**CME CREDIT UNION AND CRIMPSON CUP COFFEE SHOP
FINAL DEVELOPMENT PLAN**

LOCATION: Located at the southwest corner of Beech Road and Smith's Mill Road
(PID: 093-106512-00.00)
APPLICANT: Brian Wellert
REQUEST: Final Development Plan
ZONING: Beech Crossing I-PUD
STRATEGIC PLAN: Retail
APPLICATION: FDP-77-2023

Re: Credit Union Crimson
Coffee - FDP
2nd Submittal

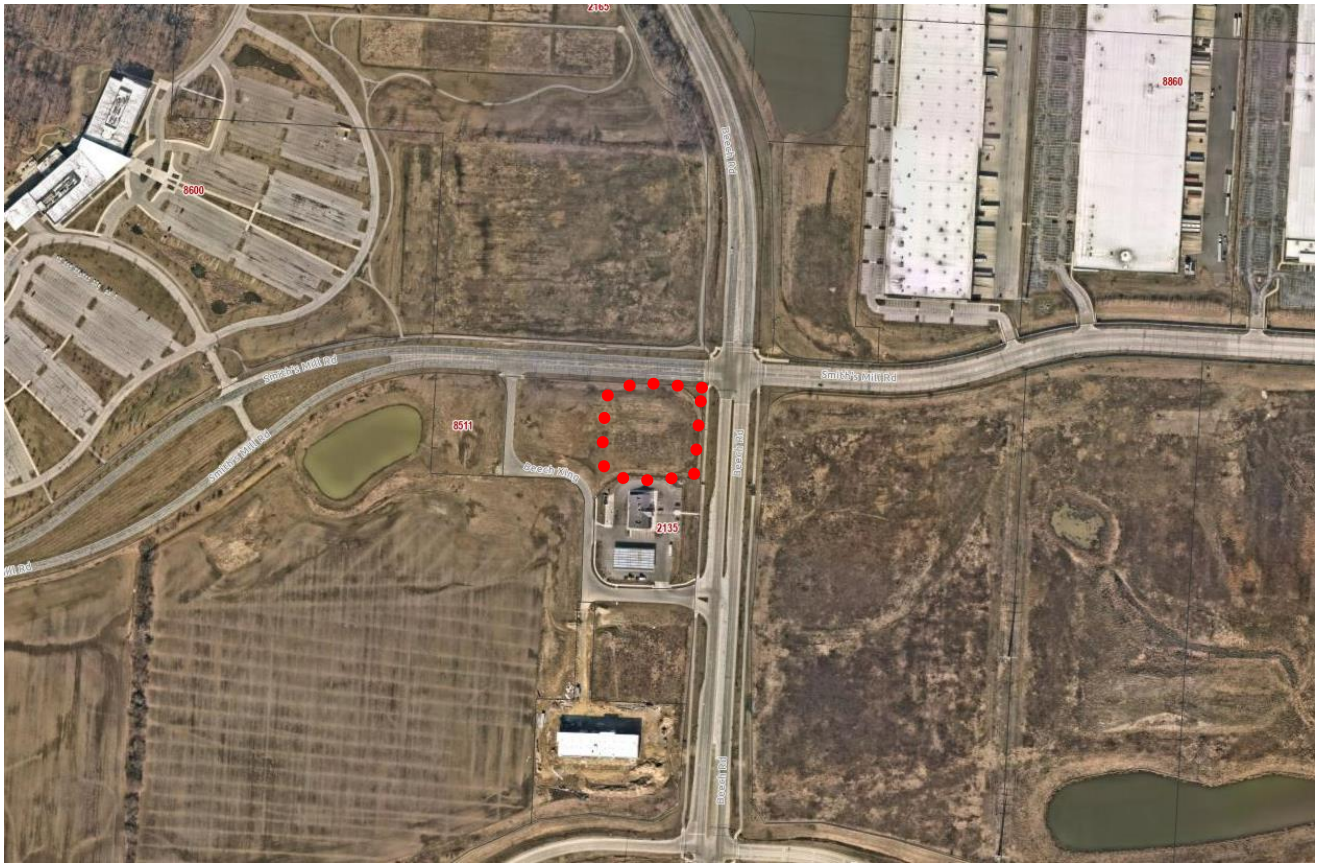
- b. The diagram below contains recommended revisions to the site plan to ensure the building is appropriately oriented to the public streets.
 - i. Rotate the building 90 degrees counterclockwise so the drive-through is located on the south side of the building, provide a shared drive with the western adjoining future development, and align the building and parking to match the existing neighbor to the south. All of these changes help achieve the important consistency and cohesiveness along the public corridors.

- ii. Relocate the dumpster, enclosure, and loading area to the interior of the site, and out of view from traffic on Beech and Smith's Mill Roads.
 - iii. Add a second doorway to the two-story architecture feature so there are entrances along Smith's Mill Road and Beech Road after the building is rotated. Relocate parking to the rear of the site.

Per code section 1159.08, the planning commission should consider structures with regard to their visual impact. The orientation of the building has a visual impact on the public streets. The purpose of the New Albany Design Guidelines and Requirements (DGR) is to help ensure that the New Albany community enjoys the highest possible quality of architectural design. The building architecture meets the city DGR requirements, however, rotating the building as staff suggests will result in the building’s two-story architectural feature to be appropriately positioned on the site. The building’s proposed orientation results in the “service” elevation that contains the

dumpster, drive through menu sign, utility boxes and meters, and service doors, which are typically the rear of the building, to face Smith's Mill Road.

The planning commission has historically approved retail sites with operable and active front doors along primary streets and have only approved menu board signs to be located on sides of the building or private drives. Locating the menu board sign and dumpster in front of the building along Smith's Mill Road is not consistent with the immediate retail design pattern or other retail areas in New Albany.

1. The city's design consultant's comments shall be addressed, subject to staff approval;
 1. Rotate the building 90 degrees counterclockwise so the drive-through is located on the south side of the building, provide a shared drive with the western adjoining future development, and align the building and parking to match the existing neighbor to the south.

2. Relocate the dumpster, enclosure, and loading area to the interior of the site, and out of view from traffic on Beech and Smith's Mill Roads.
 3. Add a second doorway to the two-story architecture feature so there are entrances along Smith's Mill Road and Beech Road after the building is rotated.
